RE: **1-ZN-2023 and 1-GP-2023**
6C692 (Key Code) and 98T77 (Keycode)
Pinnacle Peak Doggy Daycare

Planning & Development Services has completed review of the above referenced development application. The following comments represent issues or deficiencies identified by the review team and are intended to provide you with guidance for compliance with city codes, policies, and guidelines.

PRELIMINARY Basis of Design Report	
<input type="checkbox"/> ACCEPTED	
<input type="checkbox"/> ACCEPTED AS NOTED	
<input checked="" type="checkbox"/> REVISE AND RESUBMIT	
<small>Disclaimer: If accepted, the preliminary approval is granted under the condition that a final basis of design report will also be submitted for city review and approval (typically during the DR or PP case). The final report shall incorporate further water or sewer design and analysis requirements as defined in the city design standards and policy manual and address those items noted in the preliminary review comments (both separate and included herein). The final report shall be submitted and approved prior to the plan review submission. For questions or clarifications contact the Water Resources Planning and Engineering D

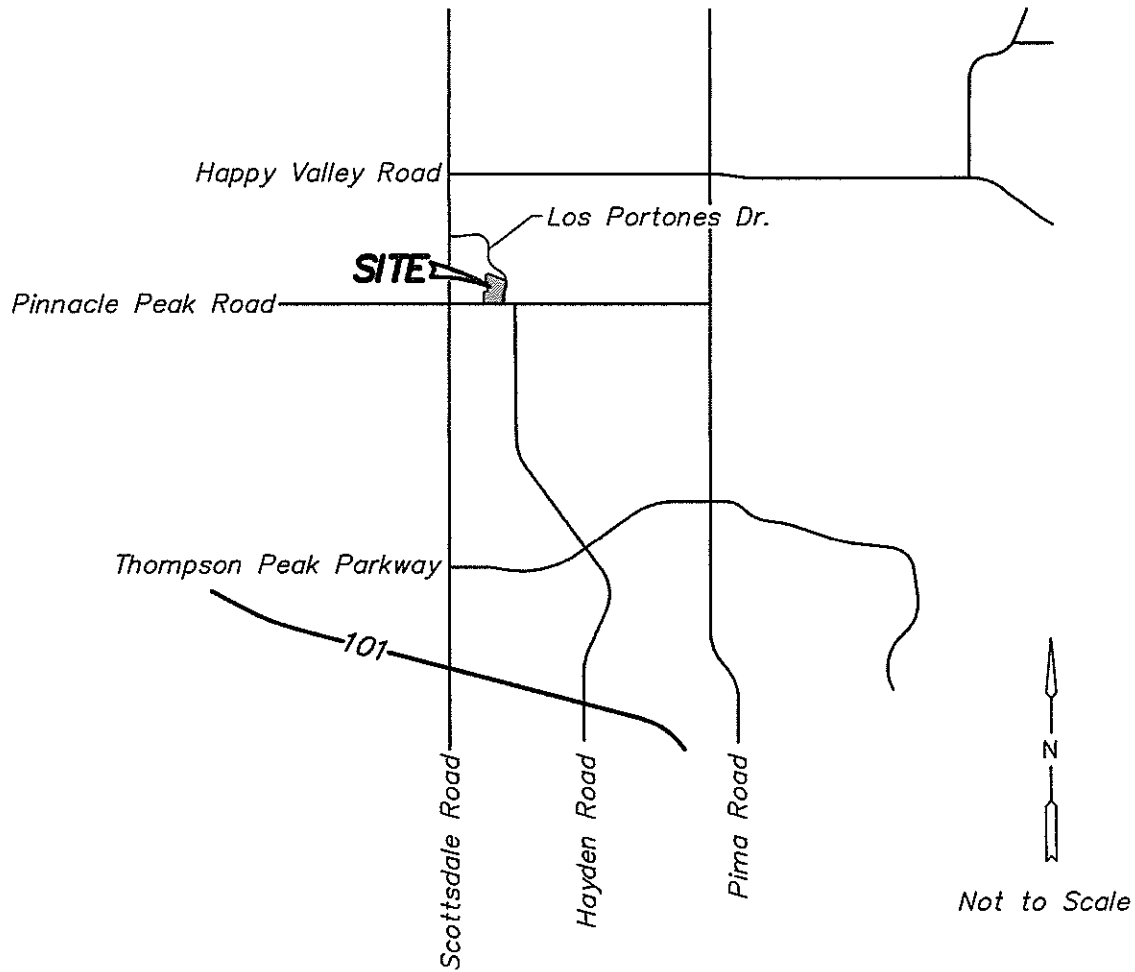
Provide Basis of Design information, including but not limited to, domestic and fire flow demands per DSPM 6-1.200, 6-1.20, Figure 6-1.2, 6-1.402, 6-1.404, 6-1.405, 6-1.406, 6-1.413, 6-1.414, 6-1.415, 6-1.416, 6-1.419, 6-1.501, 6-1.502, 6-1.507.

"PINNACLE PEAK PET RESORT" SEWER EXHIBIT

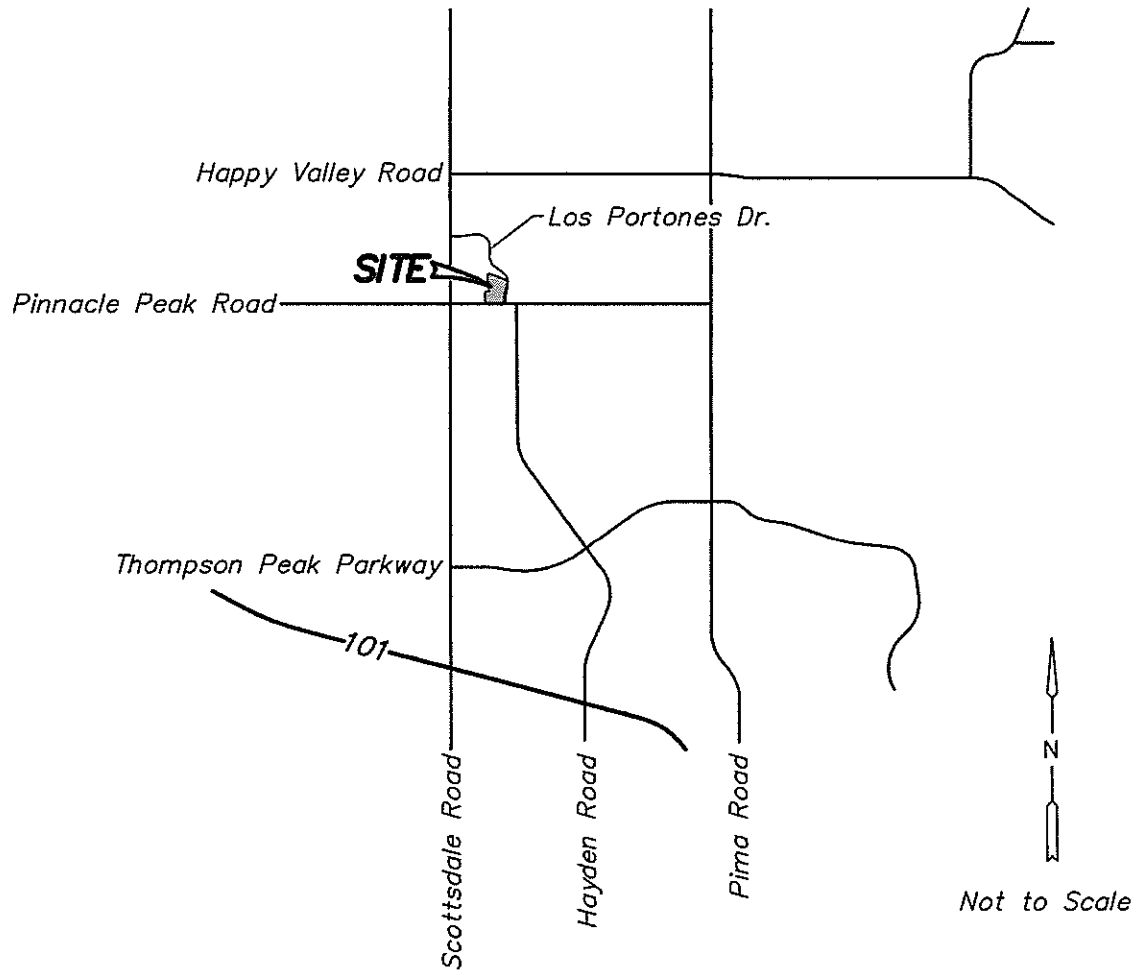
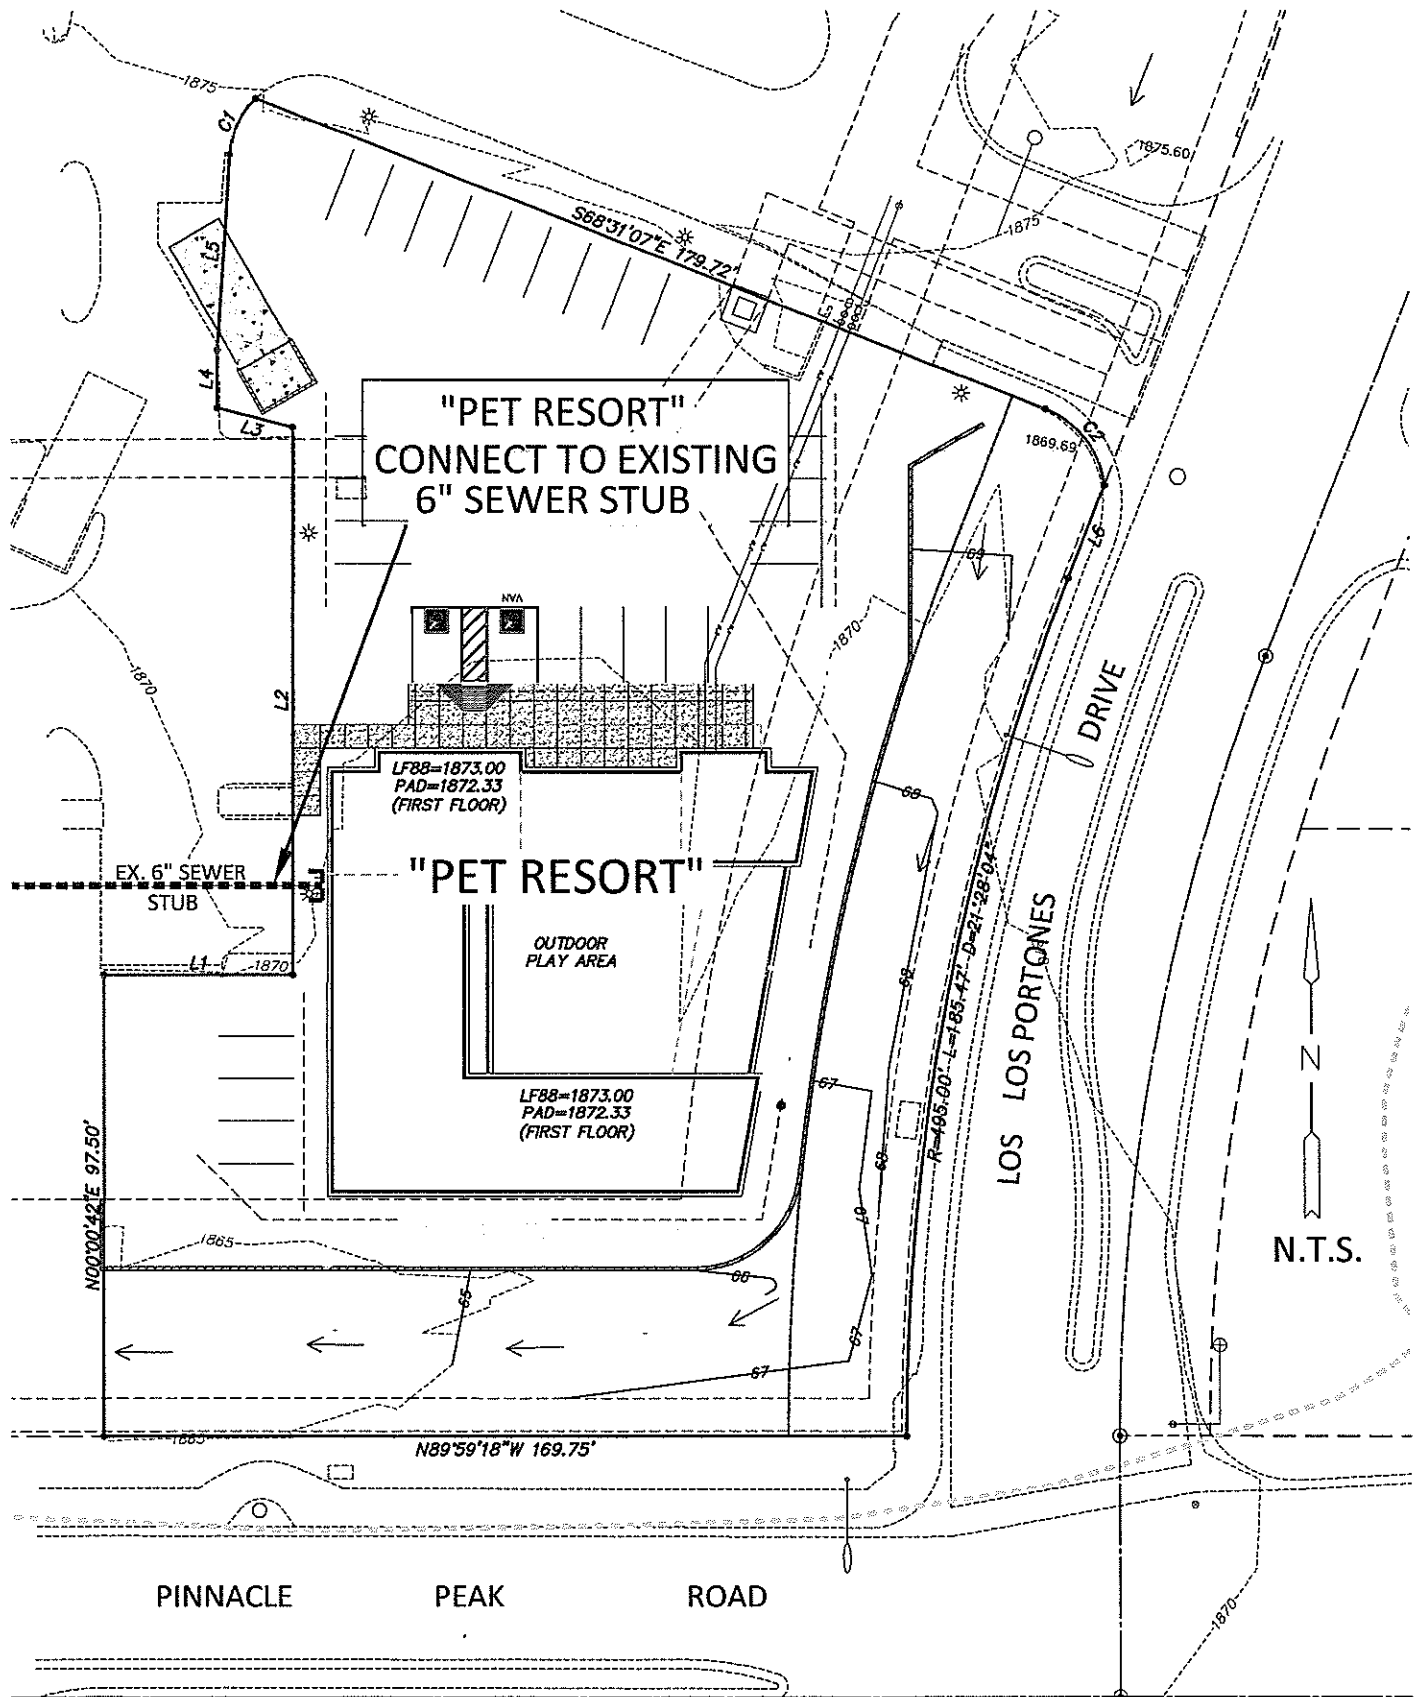
Provide first and second floor building square foot quantities and sewer demand calculations in a Basis of Design report per DSPM 7-1.200, 7-1.202 7-1.403 and Figure 7-1.2

The sewer tap identified in the Sewer Exhibit is a part of a private sewer system. Provide design drawings of the private sewer system this development is connecting to, demonstrating how the tap ultimately connects to the City of Scottsdale Sewer system. Show any sewer ejectors or private lift stations associated with the private system, as applicable. DSPM 7-1.414.

Identify the responsibility for operating and maintaining the private sewer system that this lateral will connect to per DSPM 7-1.501. Provide documentation demonstrating this development has permission from the Pinnacle Peak Office Park to discharge wastewater through its private sewer to the City Sewer.
